MERCUISER SERVICE BULLETIN

Number: 68-267-12

Reverse Lock Valve Readjustment - Power Trim

Shift Cable and Reverse
Lock Valve Adjustment

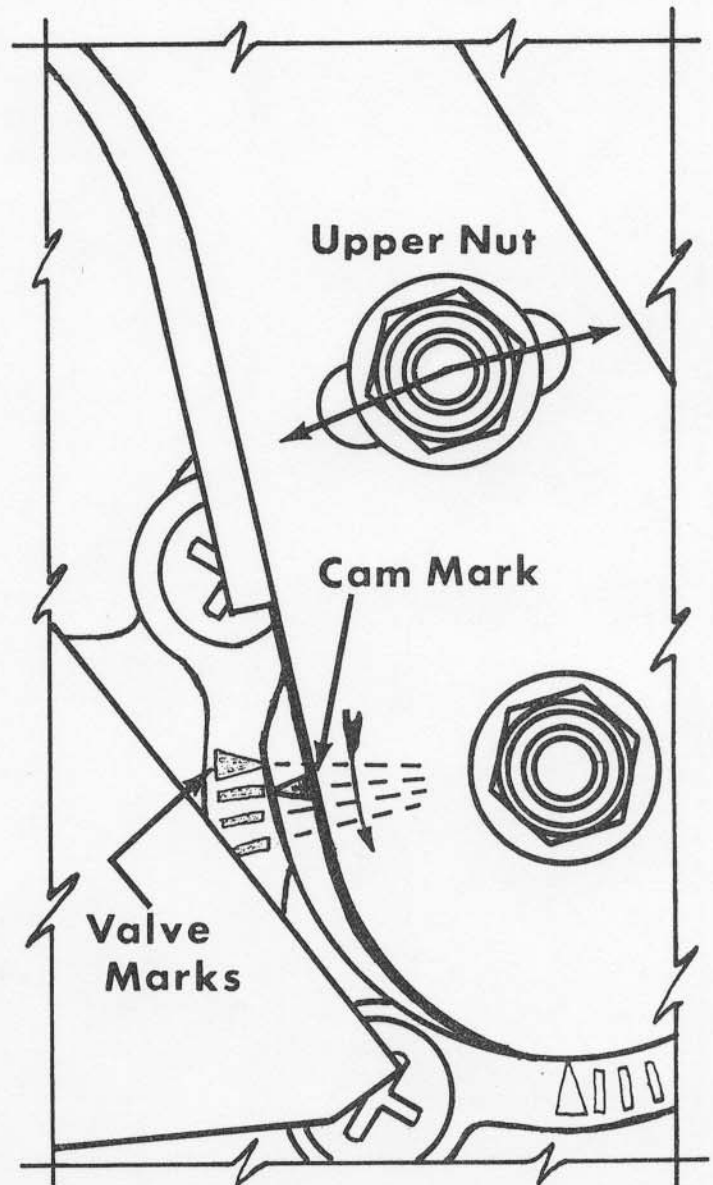
MerCruiser Stern Drives, which have improperly adjusted reverse lock valves, WILL NOT hold in reverse. If this situation exists, the shift cables and reverse lock valve require readjustment.

When shift cables have been properly adjusted, and the drive unit will not hold in reverse, readjust the reverse lock cam as follows:

1. Loosen 2 nuts on shift lever.
2. Move upper nut in direction required to line up raised triangular mark on cam with raised triangular mark on reverse valve cover, then tighten 2 nuts on shift lever.

NOTE: If the unit will not hold in reverse, move cam one mark at a time and retest boat until unit holds in reverse. Refer to figure on right.

CAUTION: The unit may be locked in neutral if the reverse lock valve is over-adjusted.
